HISTORIC PRESERVATION COMMISSION

SUBJECT: Historic Area Work Permit #656085, rear screen porch enclosure, window replacement and other alterations

MONTGOMERY COUNTY HISTORIC PRESERVATION COMMISSION
STAFF REPORT

DAYS RESIDENCE

Dates: Issue: 15 AUG 13	Page No.: 3 of 5
Revisions: REV.1 10 SEP 13	A.3

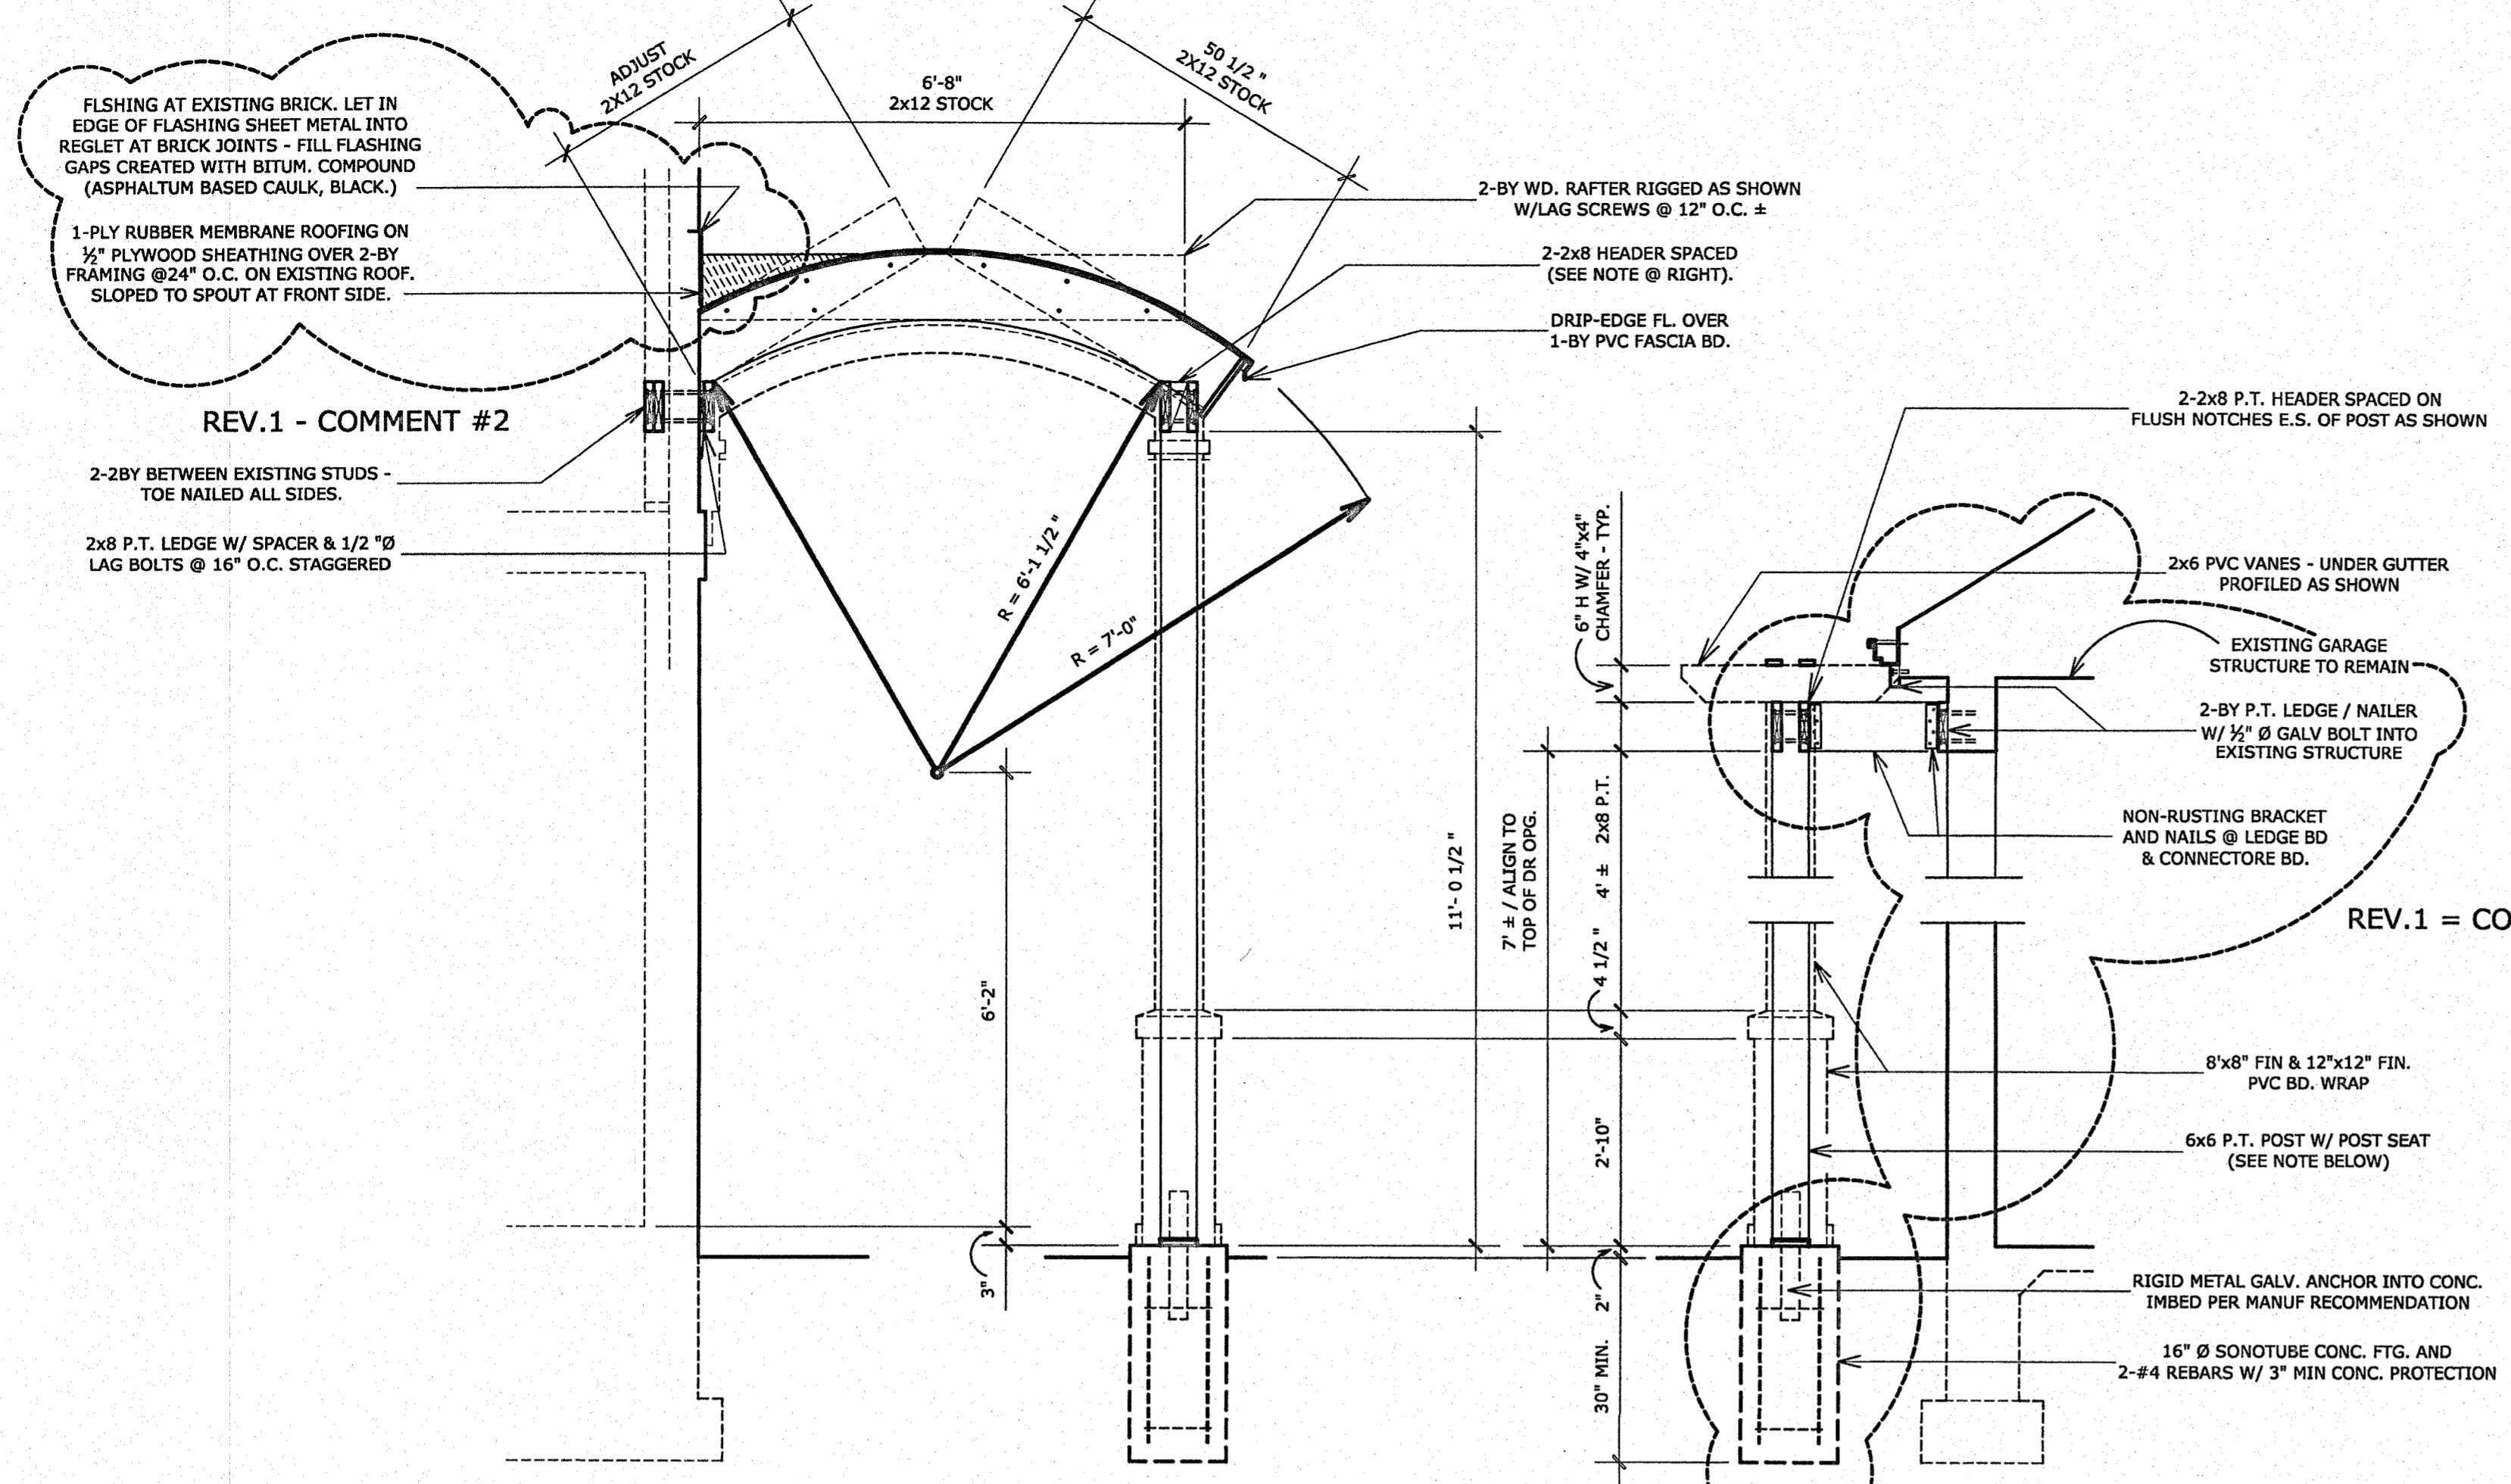
(ROOF FRAMING)
THESE PLANS MUST COMPLY WITH
SECTION R 802 OF THE 2012
1 & 2 FAMILY DWELLING
CODE AS AMENDED BY MONT. CO.

(ROOF TIE-DOWN)
THESE PLANS MUST COMPLY WITH
SECTION R 802.11 OF THE 2012
1 & 2 FAMILY DWELLING
CODE AS AMENDED BY MONT. CO.
